Flight Procedures Cover Page	Task Action: FLIGHT CHECK	Task Type: Segment	Estimated Chart Date: 11/30/2023	APWS Task ID: 7B3C10E2F5EC4973AF23250049A440FB	APWS Project ID: F6D287F6096240EB97EB407CF1F316E8
Procedure: T242 BRW VDME, AK TO TKA VDME, AK		Enroute: YES	Specialist: Gibson, Taylor		Agreement Number:
Airport ID:			Airport City:		State:
Facility ID:	Facility Type:	Flight Inspection Remark Type: New FC Slot

DOCKET NUMBER 19-AAL-67

7/7/2023: THIS IS AN UPDATED COPY OF THE FORM DEVELOPED ON 9/1/2022

8260-16 TADUE TO JOKAP:

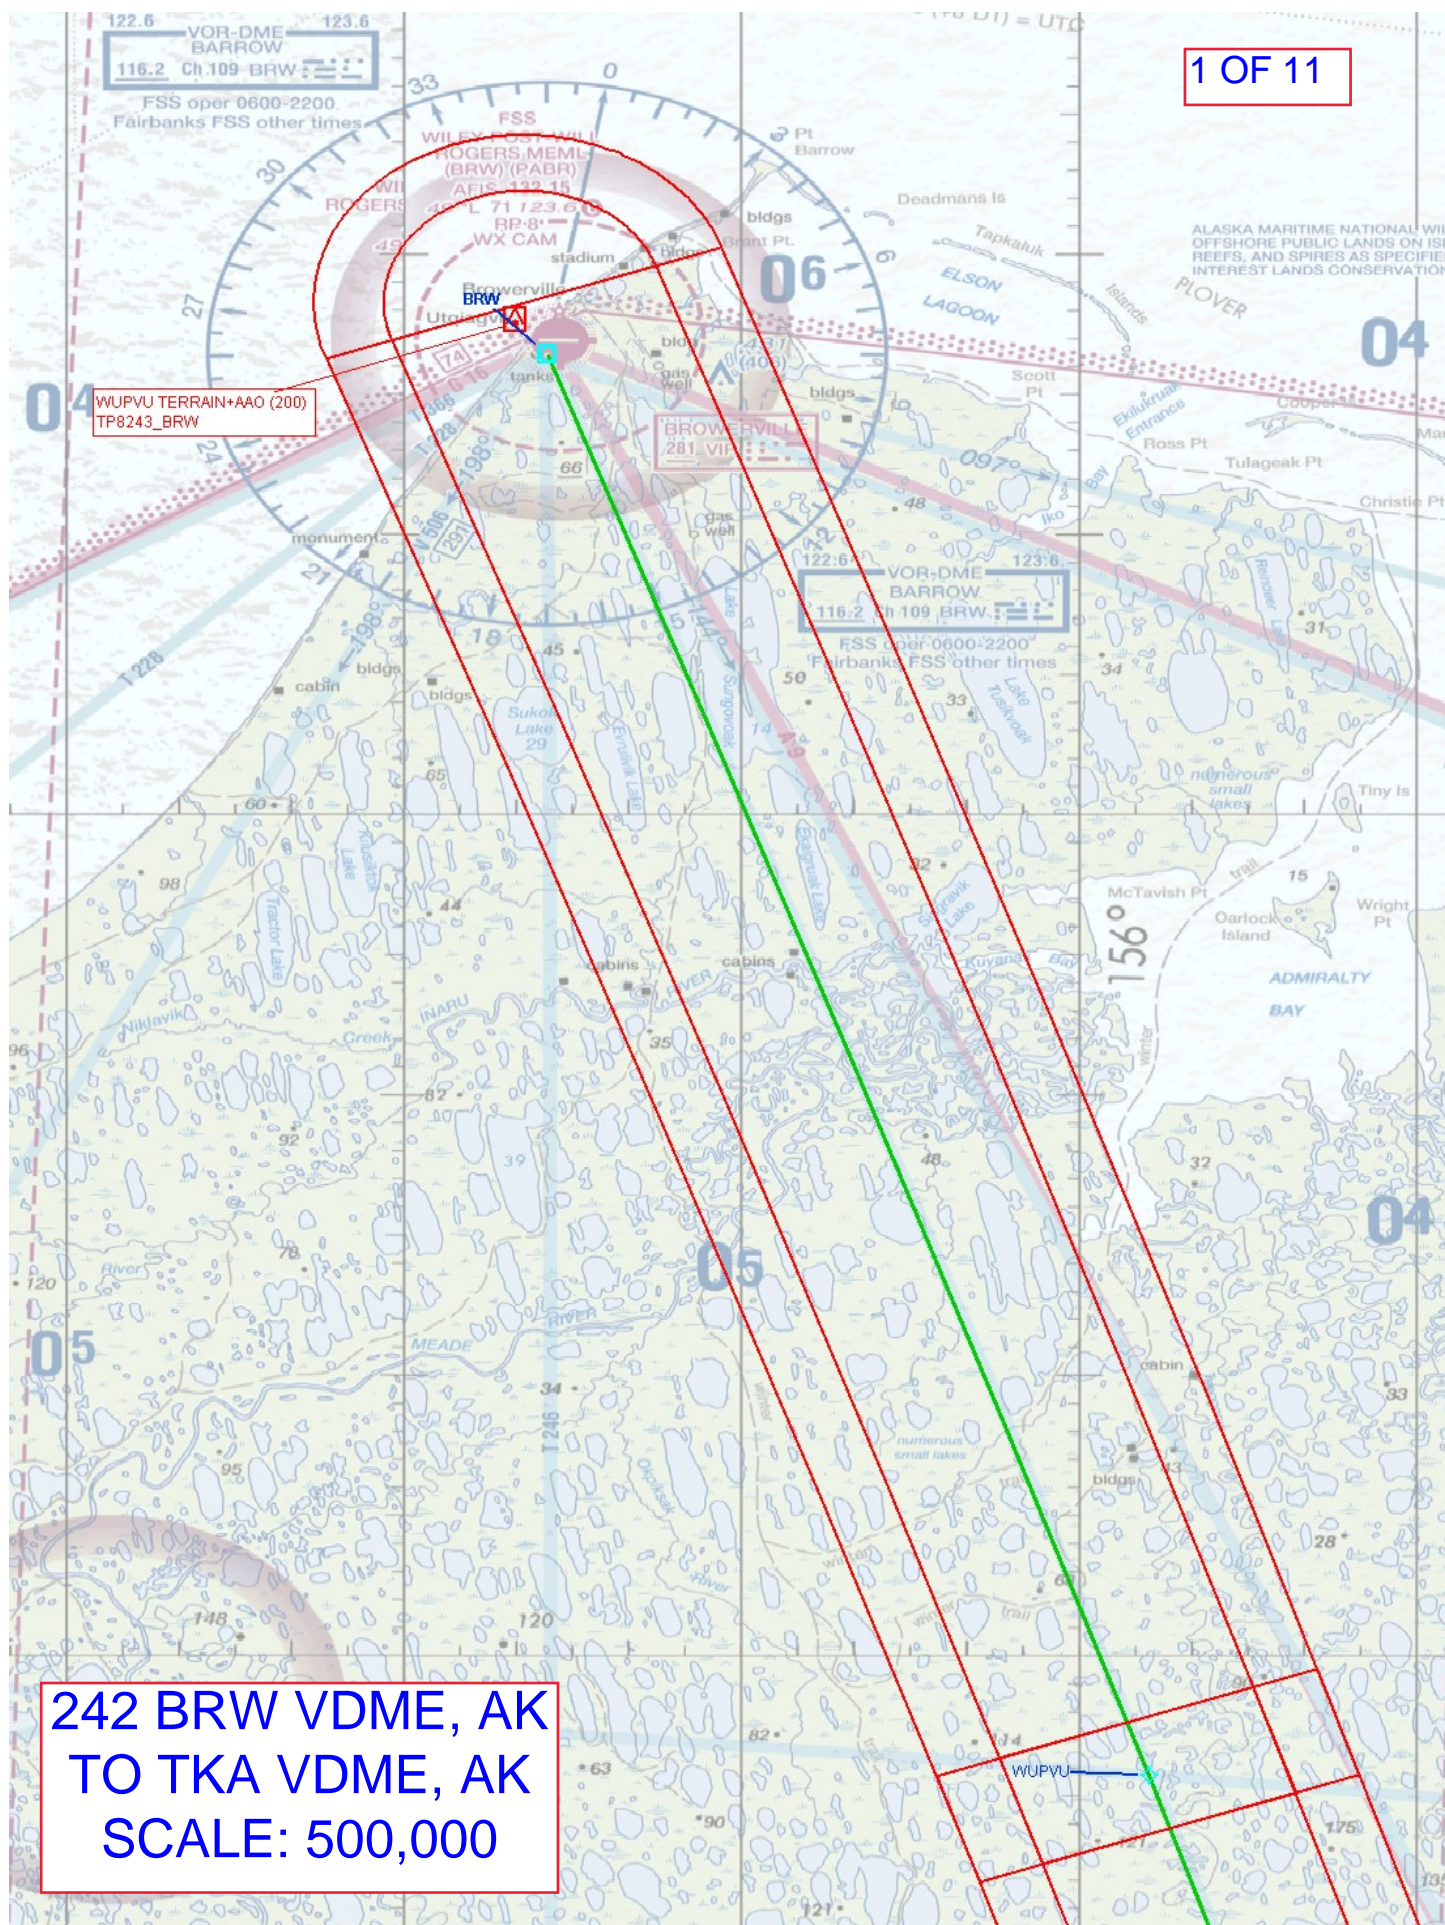
1) CHANGED CHANGES AND REASONS FROM "MRA/MOCA LOWERED FROM 6000/5800 TO 4000" TO "MRA/MOCA LOWERED FROM 6000/5800 TO 3400"

2) ADDED MCA AT JOKAP.

3) ADDED "CHANGED MCA FROM 11500 S AT JOKAP TO 10700 SE AT JOKAP" TO CHANGES AND REASONS.

08/31/2023: THIS IS AN UPDATED COPY OF THE FORM DEVELOPED ON 09/01/22. 8260-16 LACIL, AK TO KUTDE, AK 1.

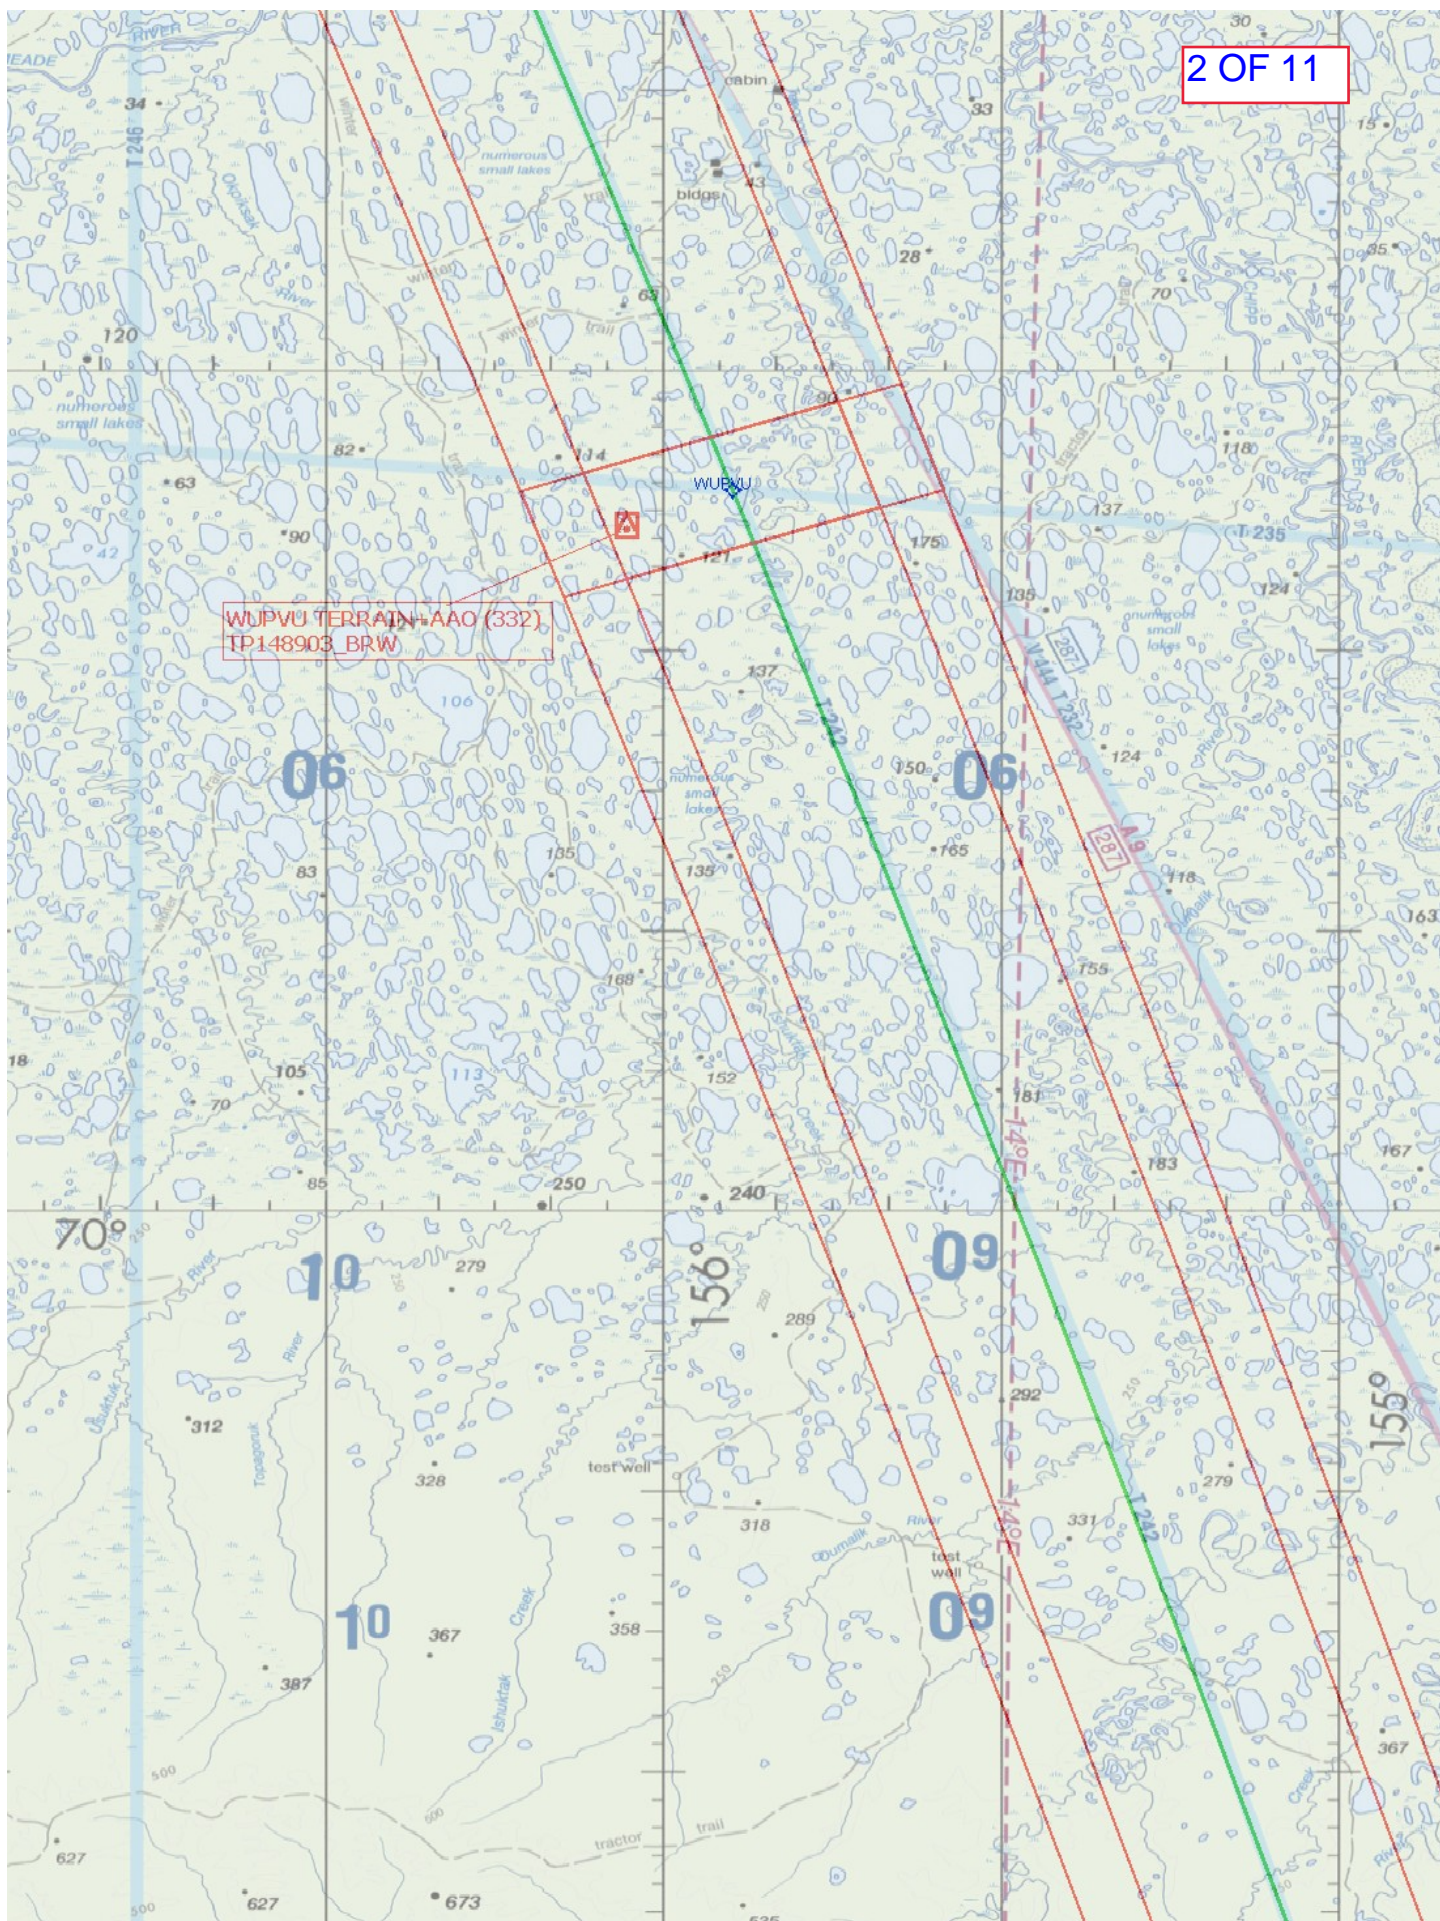
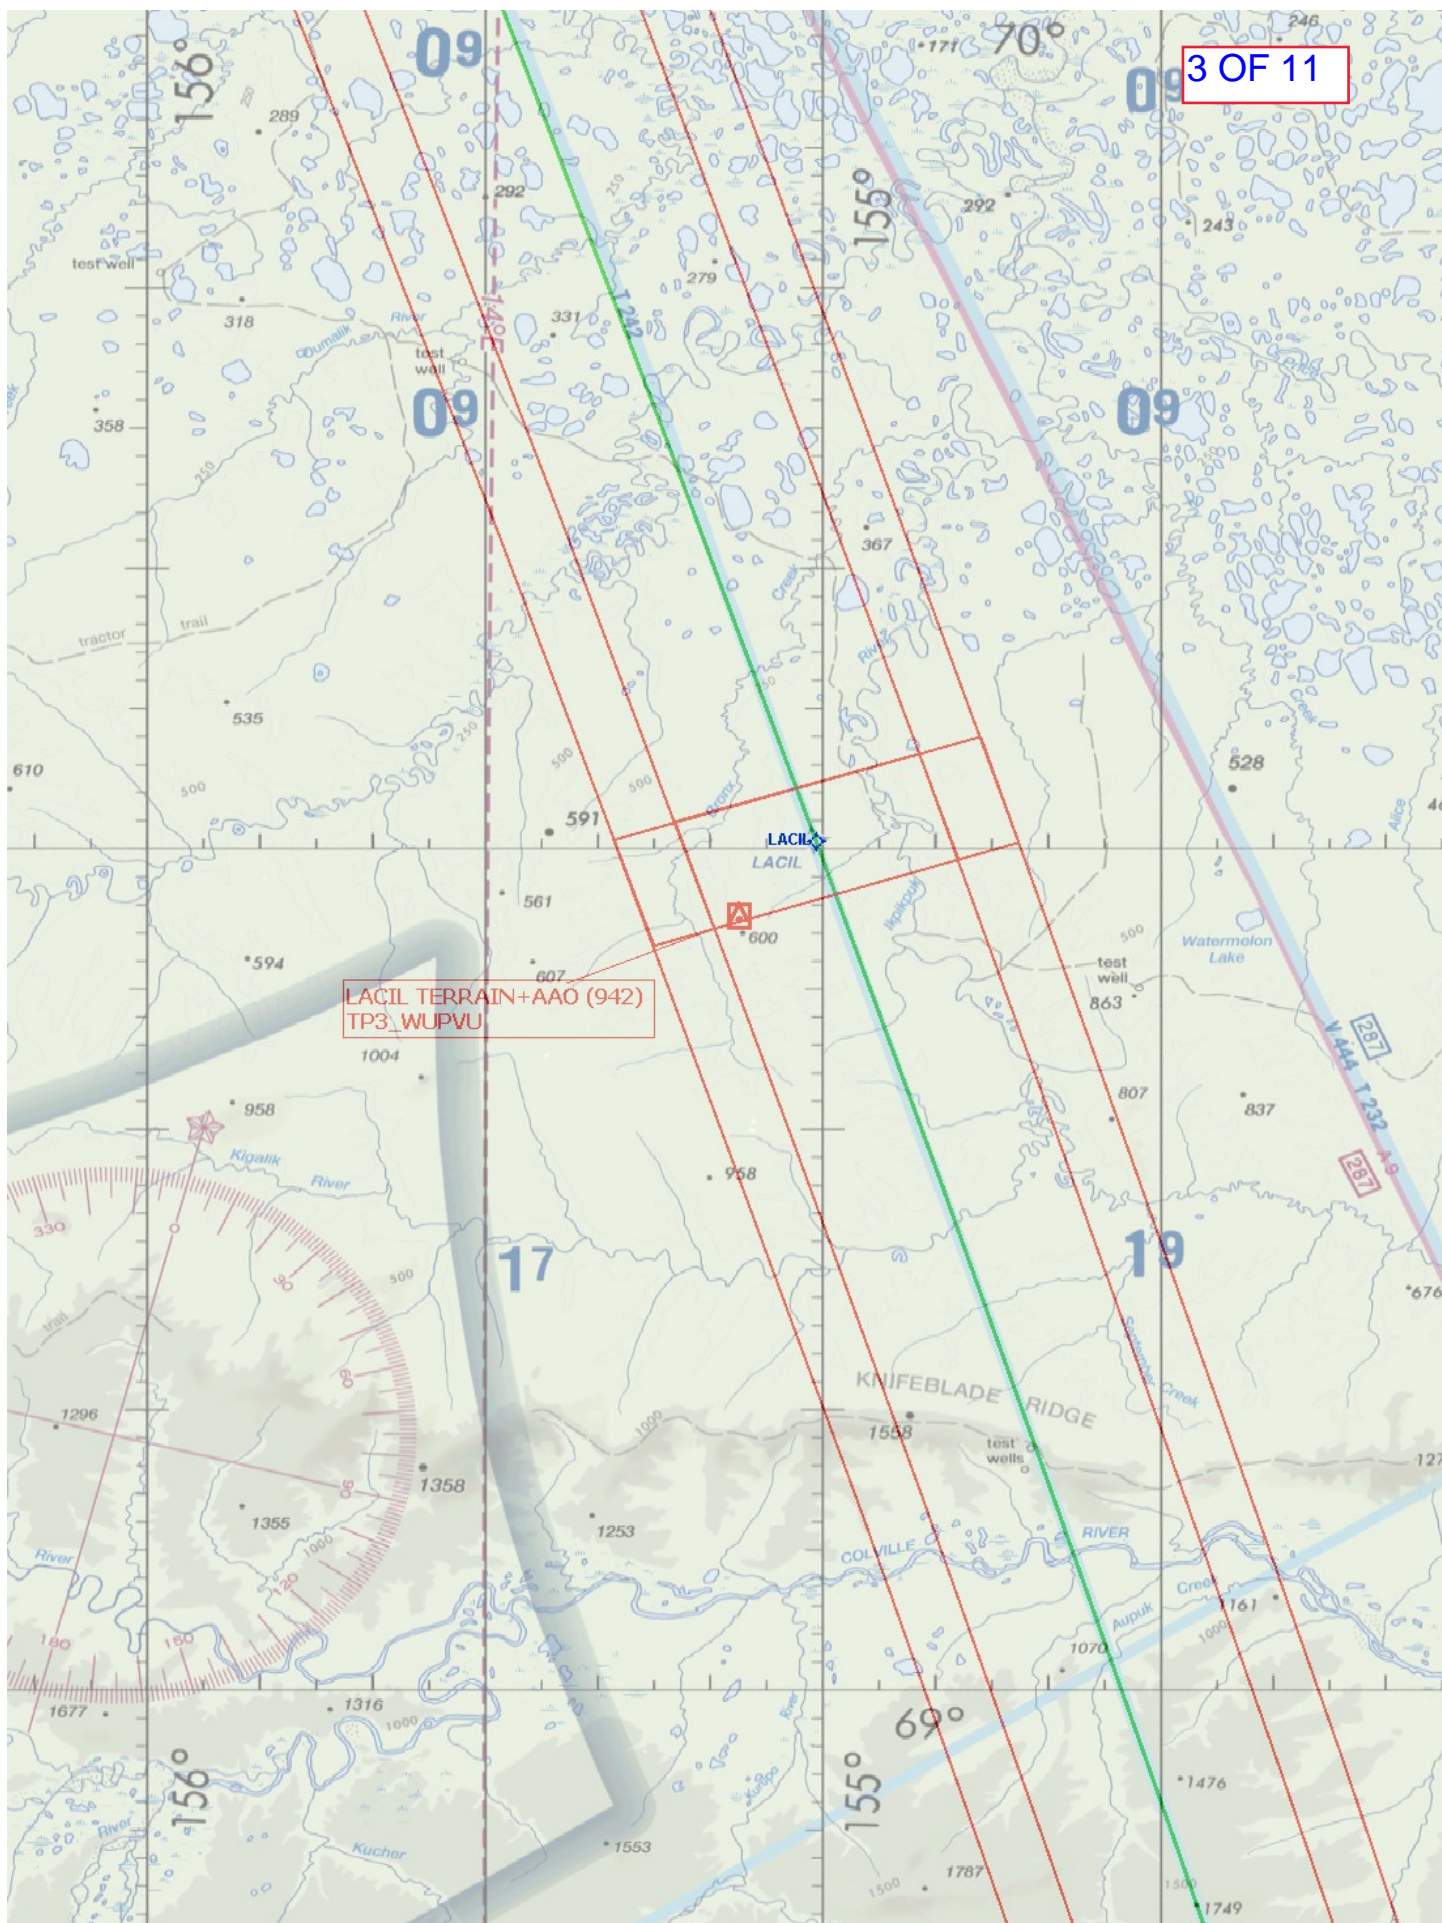
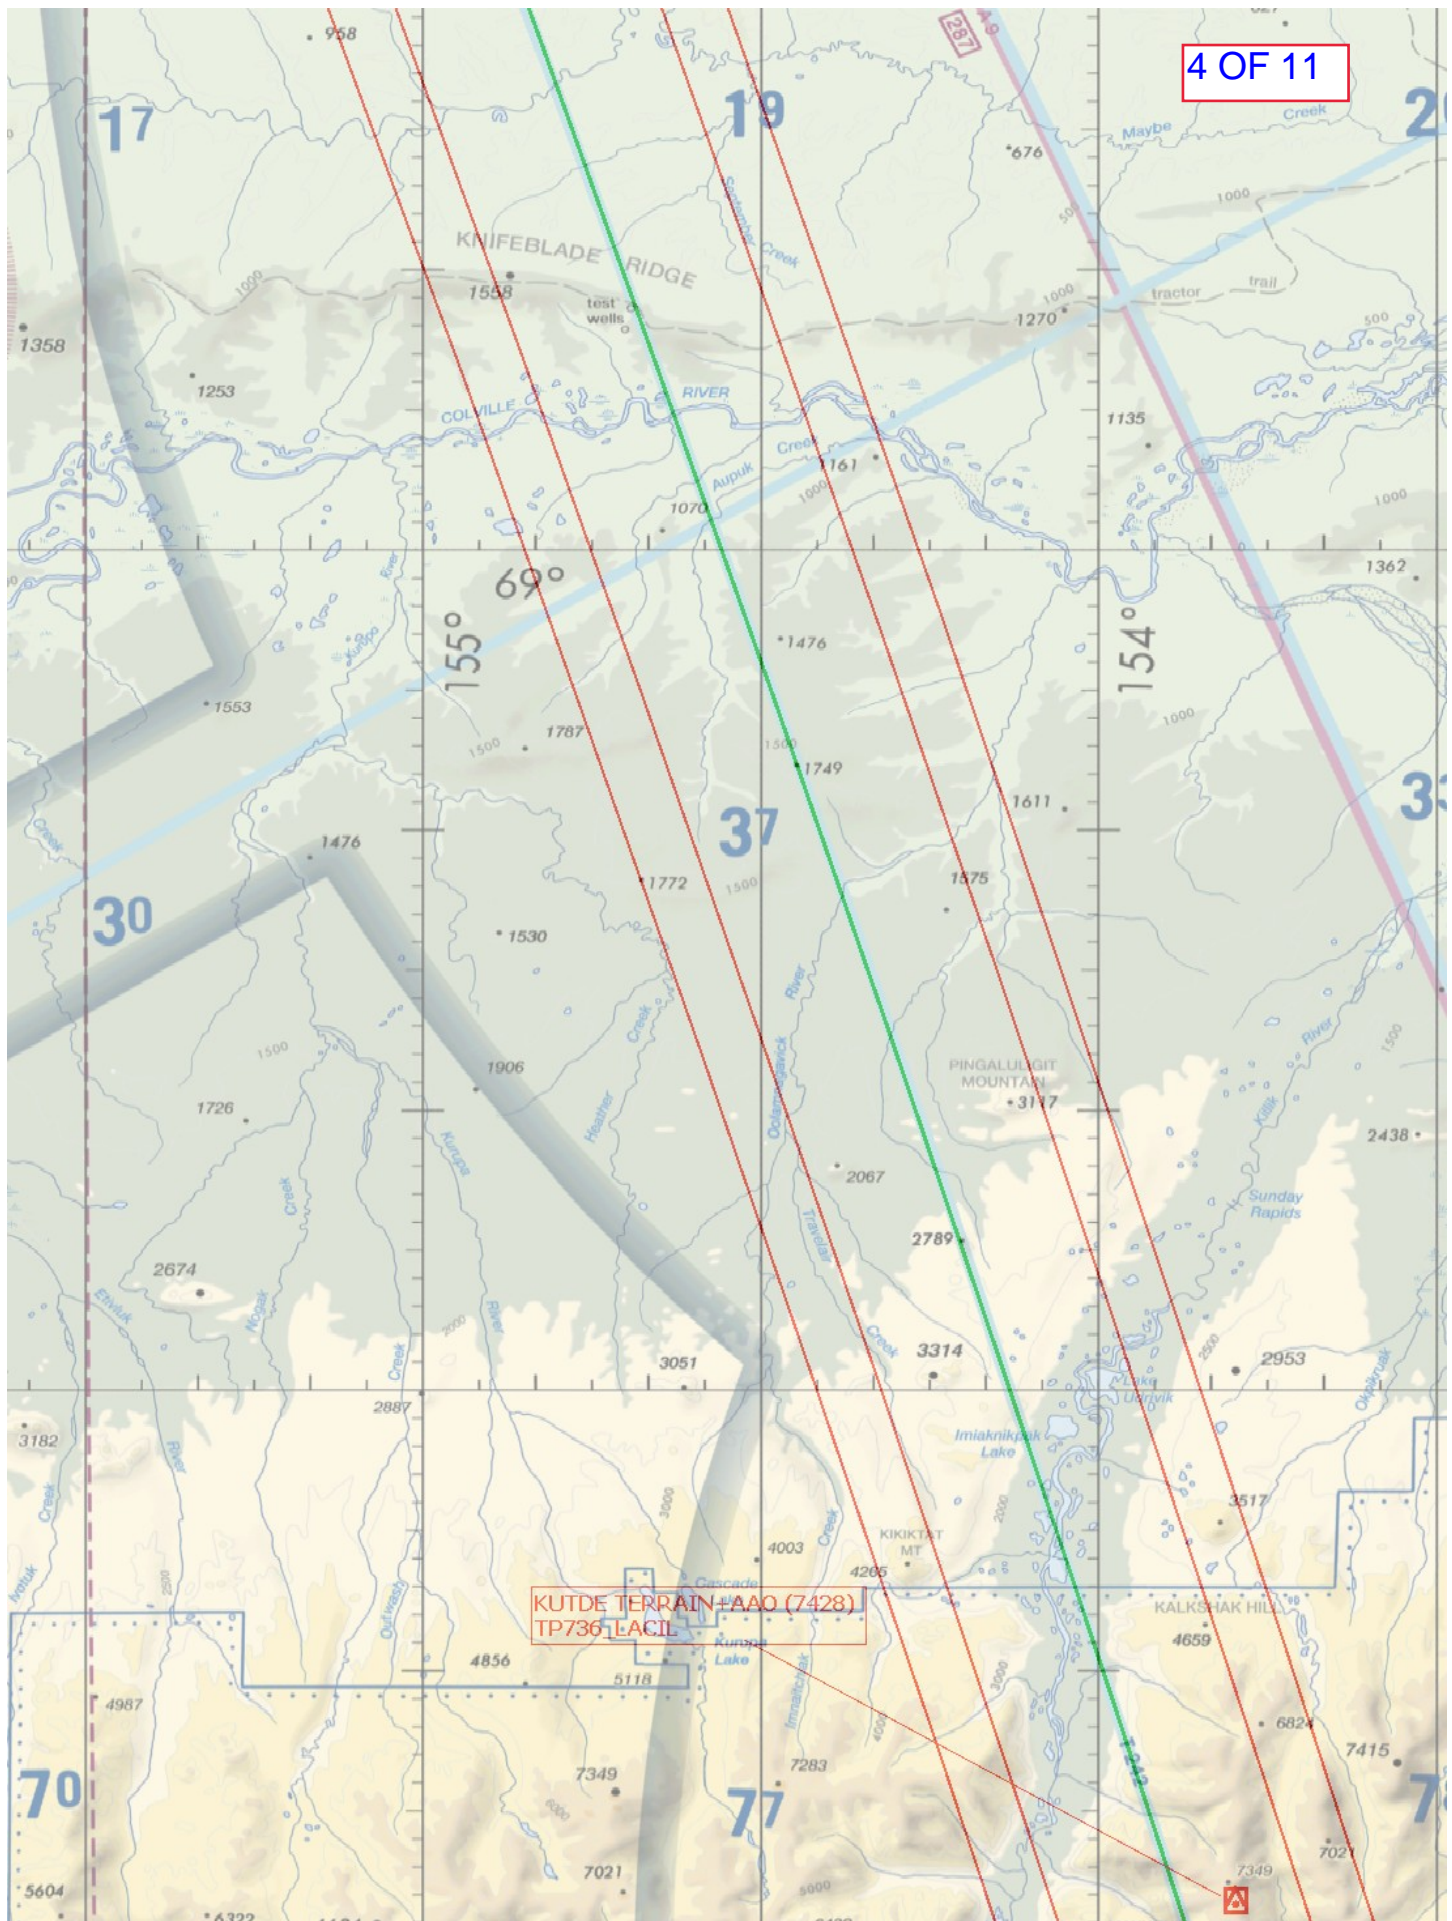
1. CHANGE MRA FROM 9500 TO 13500, MEA 13500 - PER FLIGHT CHECK REPORT
